LICENSEE POST-EXAM COMMENTS

V. C. SUMMER NUCLEAR STAION

EXAM NO. 50-0395/2000-301

SUBJECT: VIRGIL C. SUMMER REACTOR OPERATOR AND SENIOR
REACTOR OPERATOR INITIAL EXAMINATION FORMAL
COMMENTS

①

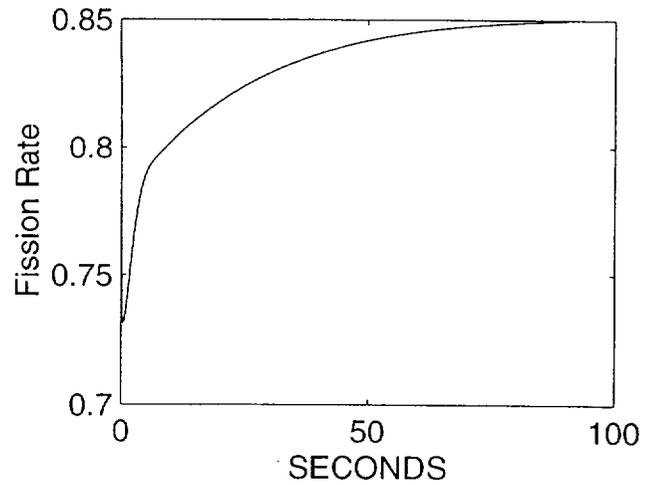
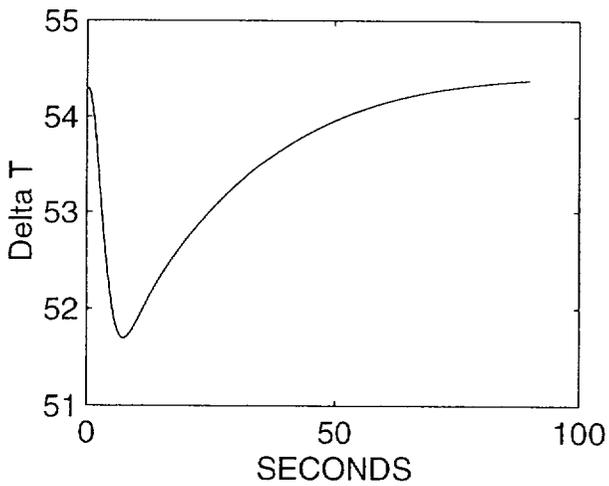
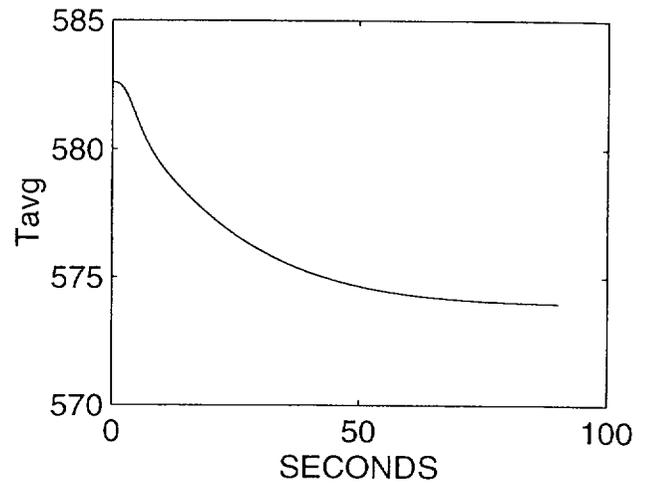
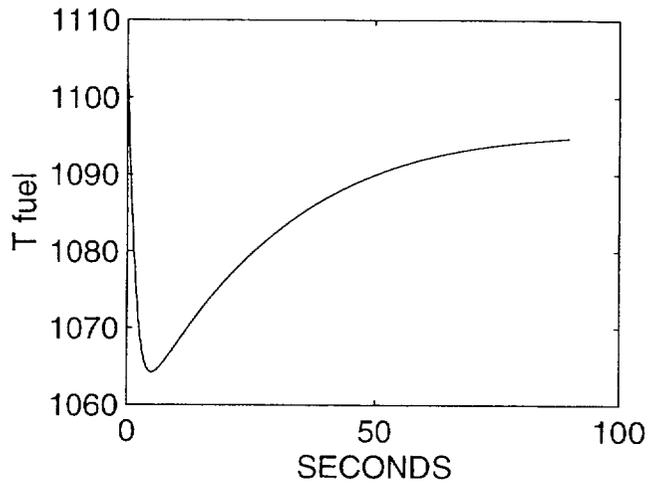
The attached graphs reflect the impact of dropping rod H2 on T_{fuel} , ΔT , T_{avg} , and power. Figures ① (BOL) and ② (EOL) with a constant secondary power (therefore, constant 1st stage pressure and constant T_{ref}). At BOL, T_{avg} changes by 7.5°F and at EOL, T_{avg} changes by only 2.5°F. In both cases, power returns to the original power level, which is a function of steam demand.

Accept either choice A. OR B.

③

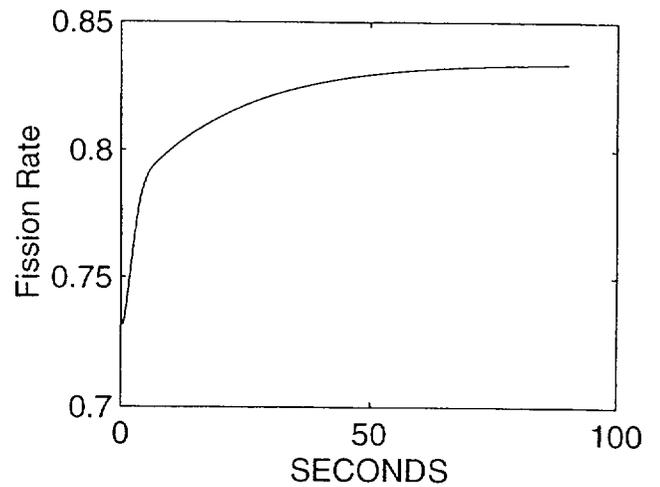
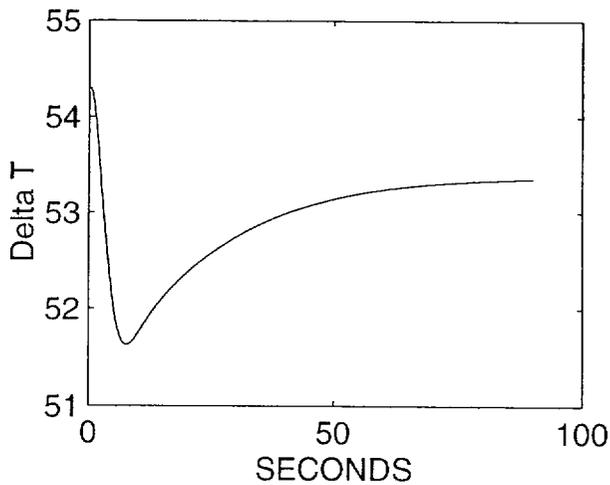
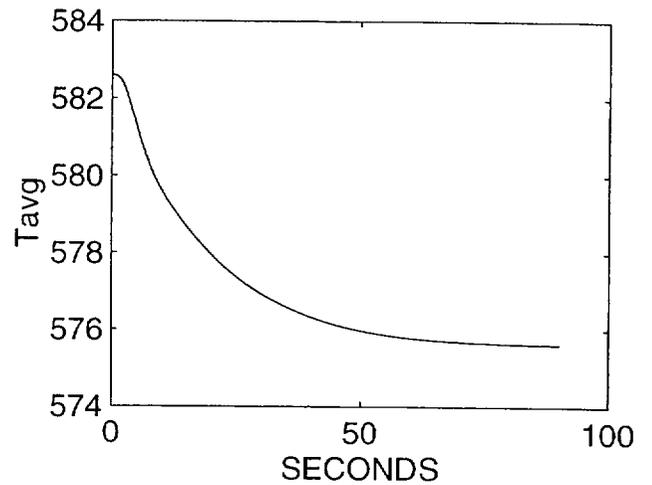
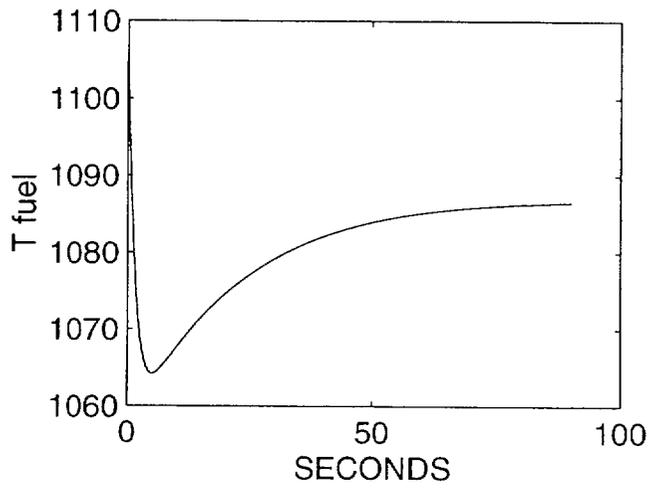
Figures ③ (BOL) and ④ (EOL) show similar results with a slight affect on steam pressure. The final power level is only slightly less than the original power level, therefore the impact on T_{ref} (1st stage pressure) is relatively small.

FIGURE VI-21
 REVISION DATE: 7/26/82
 CHECKED BY: *W. J. Clayton*
 APPROVAL: *ASB*

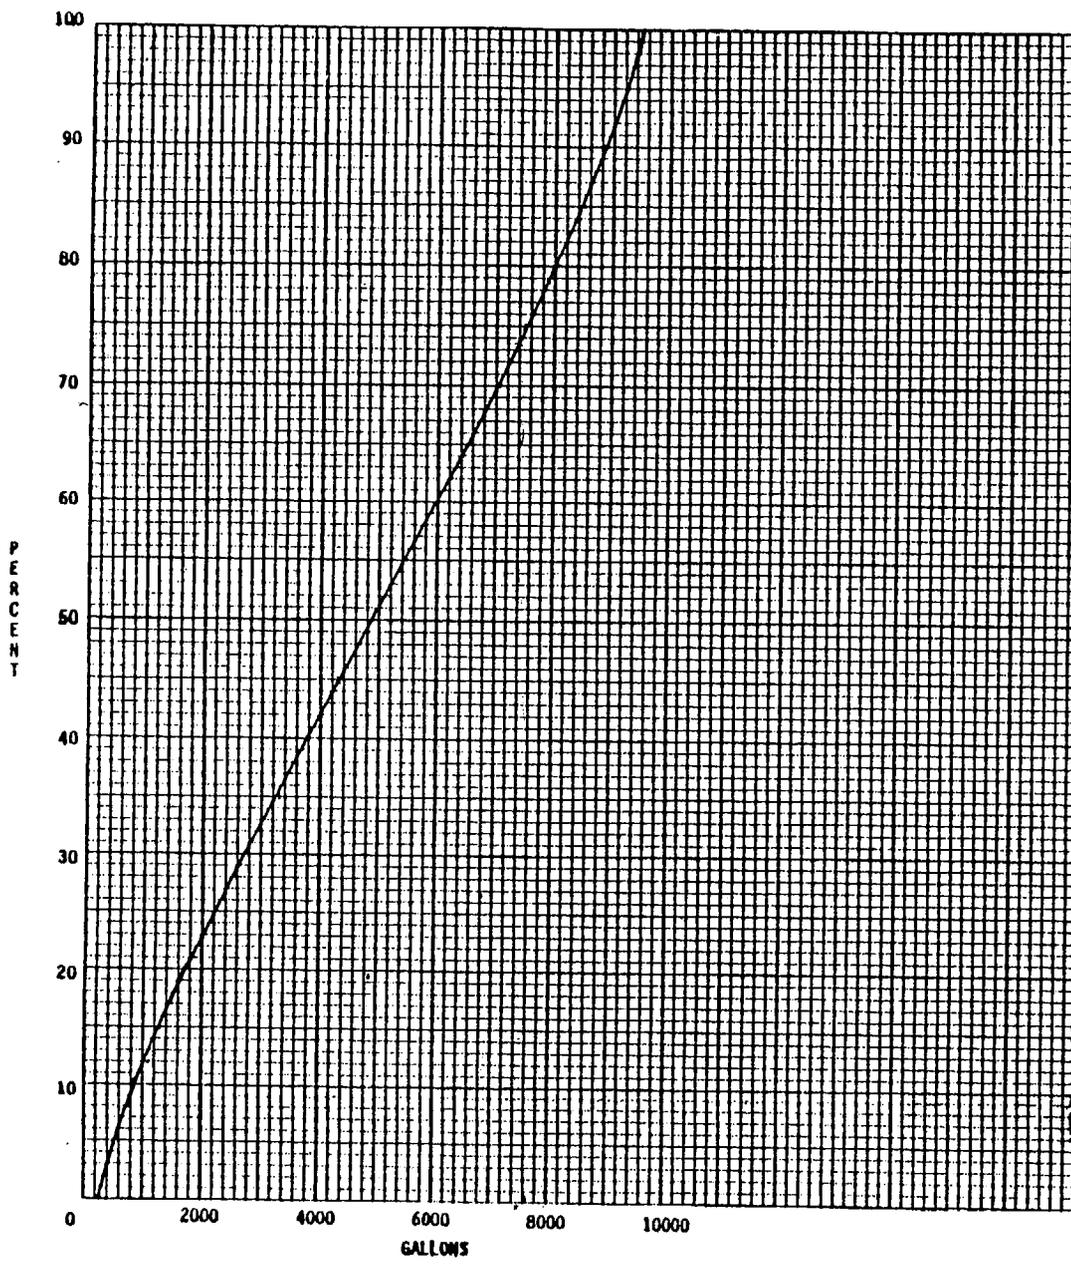
PRT Level: Accept deviation of 150-200 gallons. Minimum value based on getting 7050 gallons from table for 70% level and reading 7200 gallons from the curve. Maximum level is based on reading the curve and applying the same “parallax” i.e. if student reads 70% as 7000 gal., they should read 72% as 7200. If student reads 70% as 7050 gal., they should read 72% as 7250, etc. This gives a difference of 200.
